RE: City of Duluth Bid #11-4403
(New Passenger Terminal Bid Package 2B)

Addendum No. 2

**NEW PASSENGER TERMINAL
DULUTH INTERNATIONAL AIRPORT
DULUTH, MN**

2 WALL SECTION @ CONCOURSE CURTAIN WALL
1/2" = 1'-0"

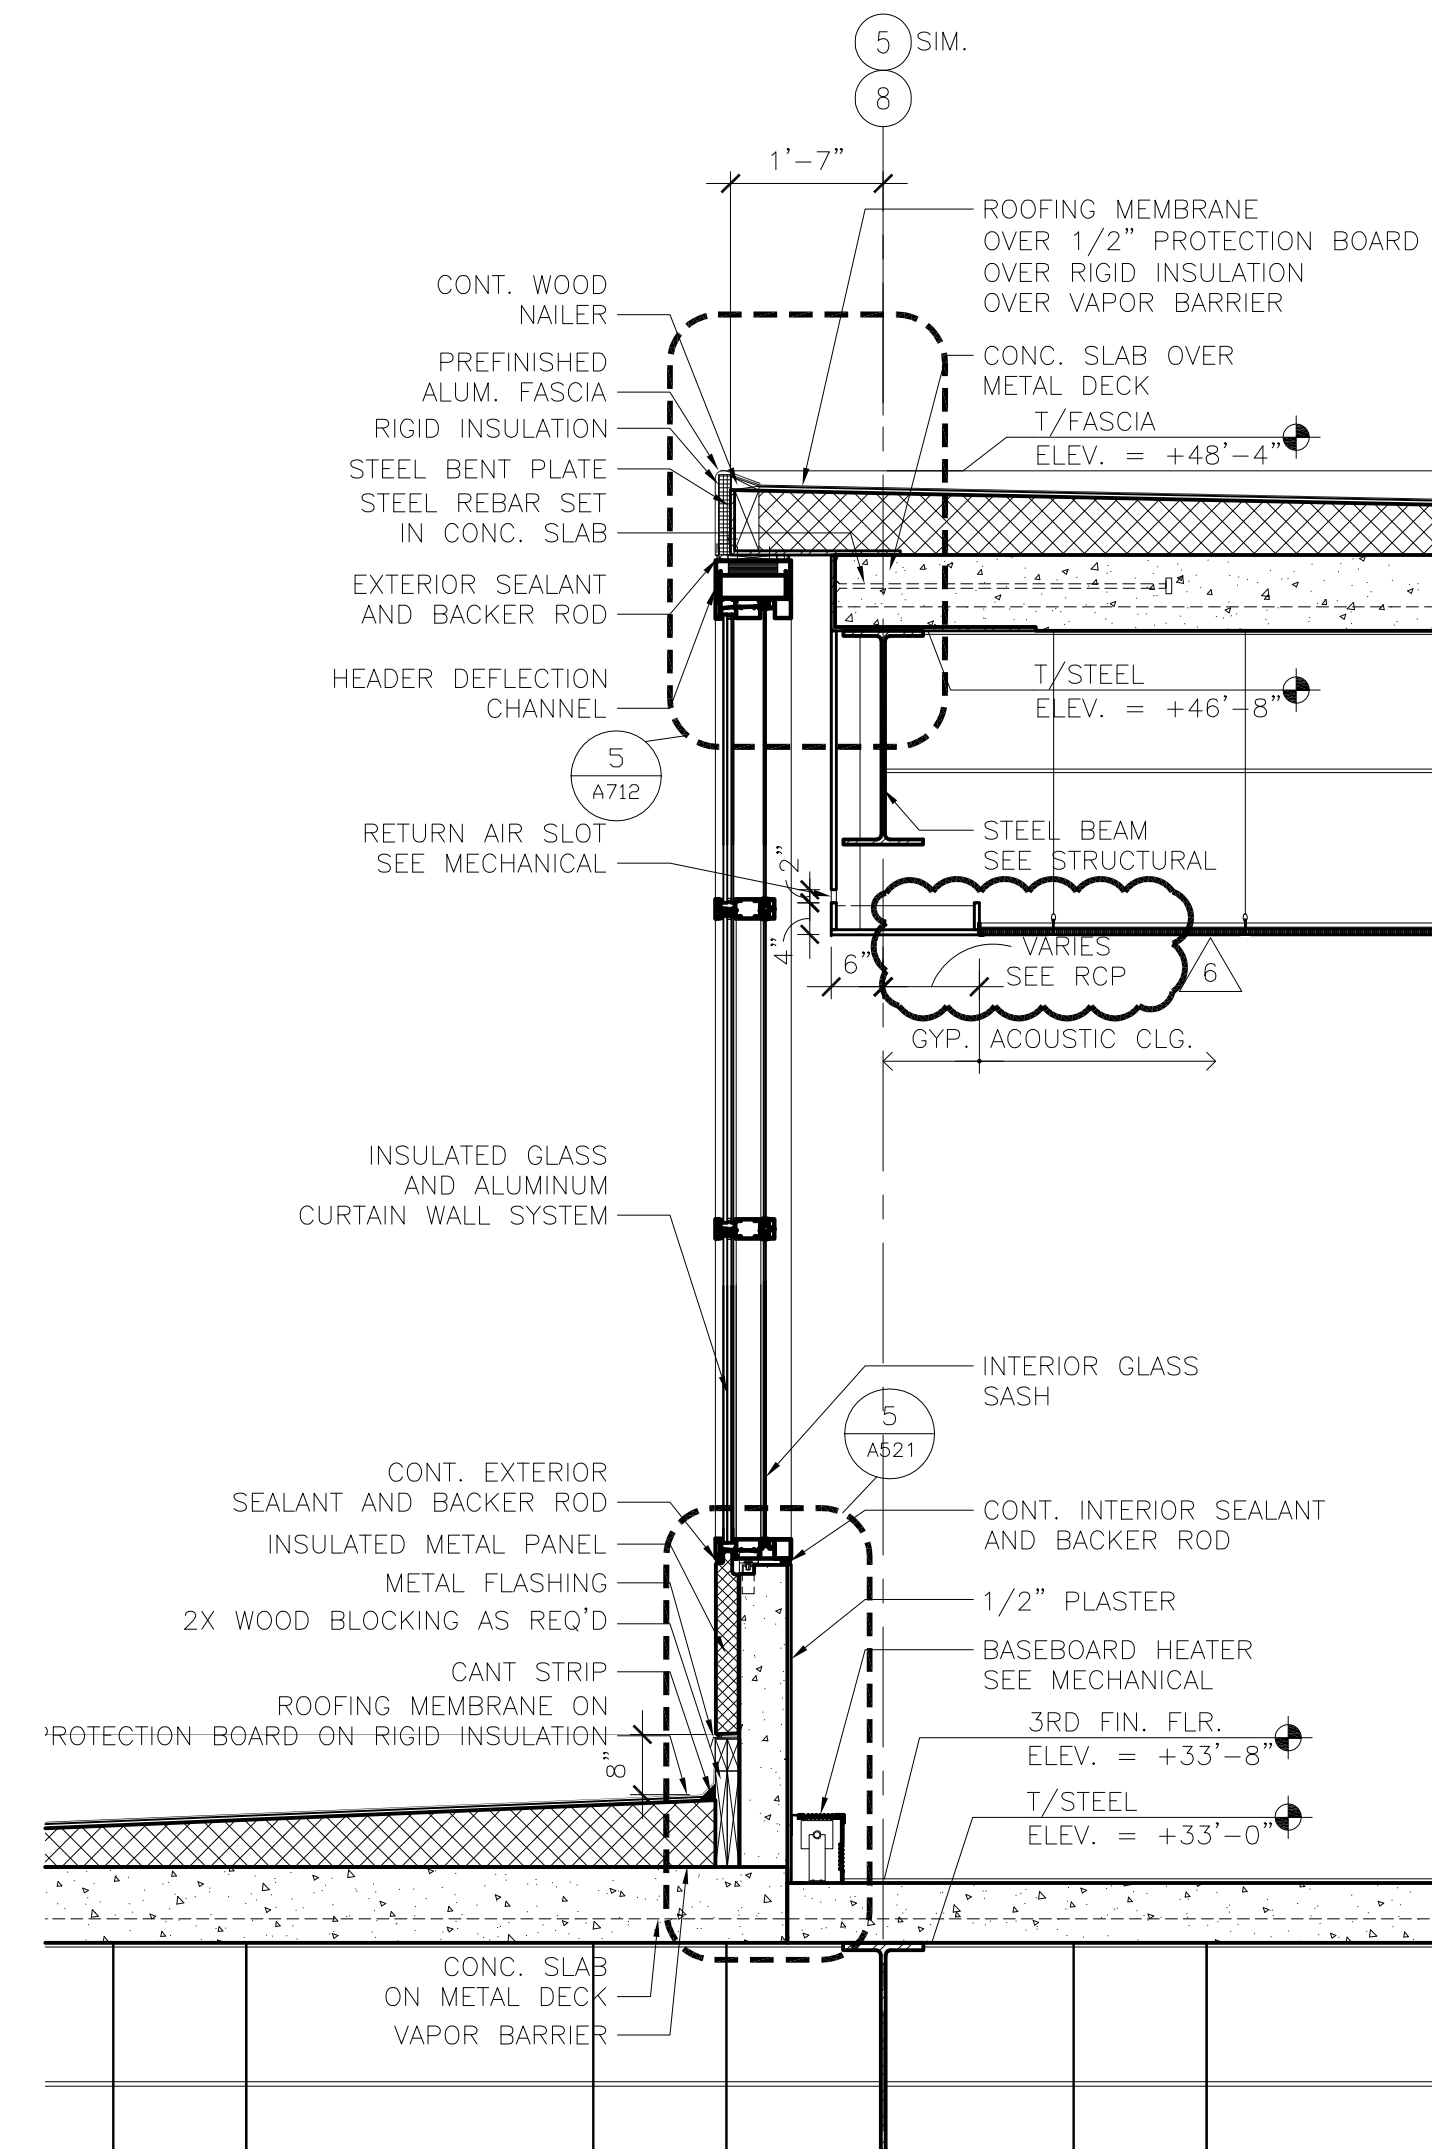
- Sheet A215: Added dimensions for gypsum board ceilings.
- Sheet A401: Revised gypsum board ceiling in Detail 1.
- Sheet A510: Revised corner guards in Detail 8.

9 SECTION DETAIL @ MEZZANINE
1 1/2" = 1'-0"

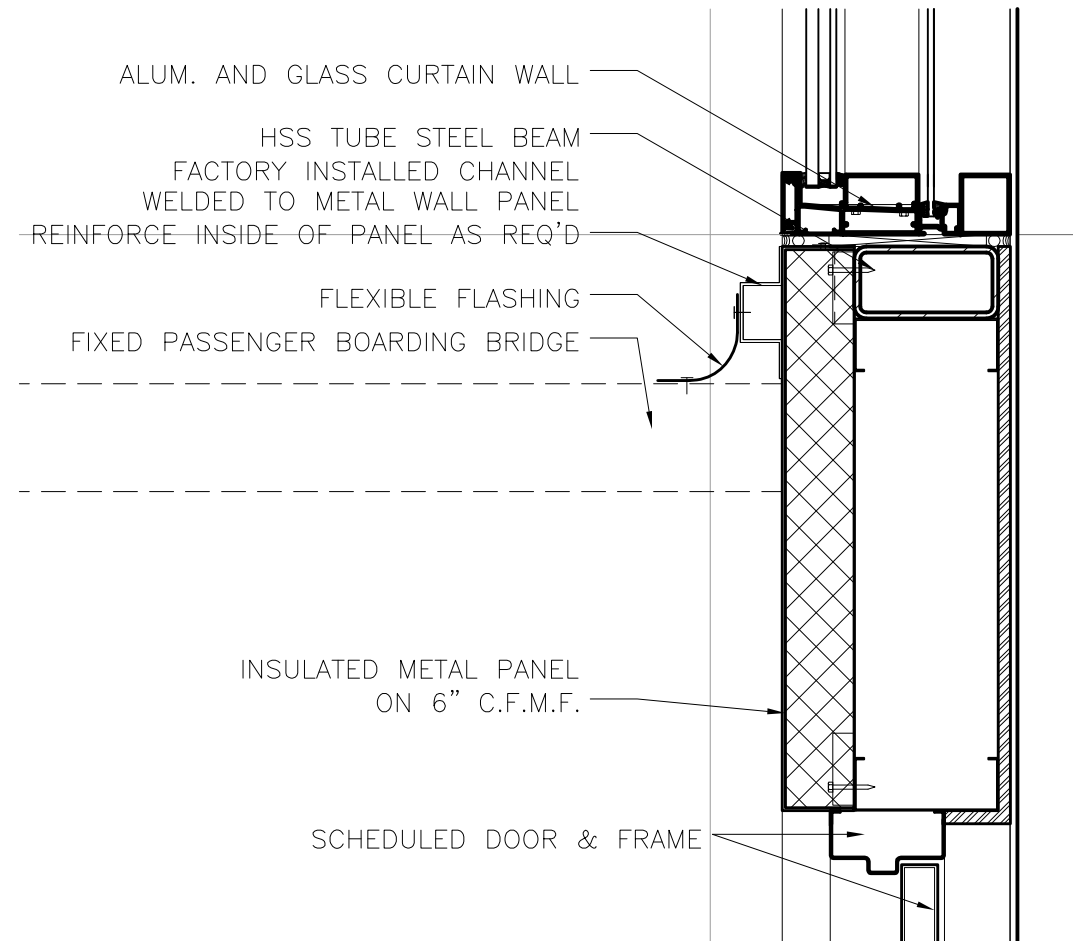
- Sheet A522: Added dimensions at guardrail in Detail 9.
- Sheet A540: Added dimensions at guardrail in Detail 10.
- Sheet A541: Added detail for guardrail.
